T&S BRASS AND BRONZE WORKS, INC.
 2 Saddleback Cove / P.O. Box 1088
 Travelers Rest, SC 29690

Model No.
000764-20

Product Specifications:
 B-0290 Removable Seat

Note: (2) Different B-0290 Seats, as of March 1997

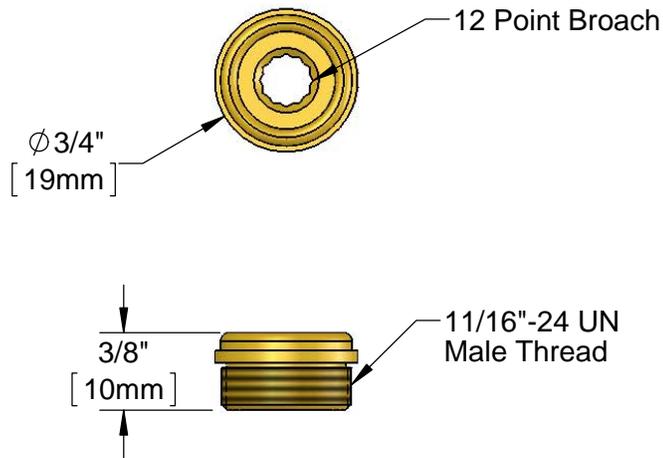
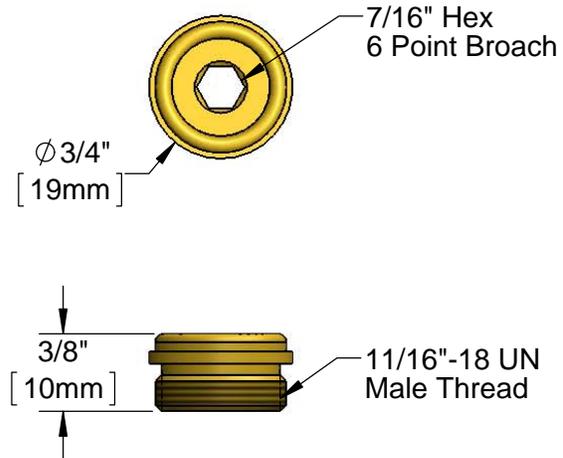
<u>Old Seats</u>	<u>New Seats</u>
Broach	12 point	6 point
Threads	24 per Inch 	18 per Inch

Old Seats Only Fit Old Faucets. New Seats Only Fit New Ones. Since We Weren't Sure Which Body You Would Be Repairing Today, We Have Included Both Types.
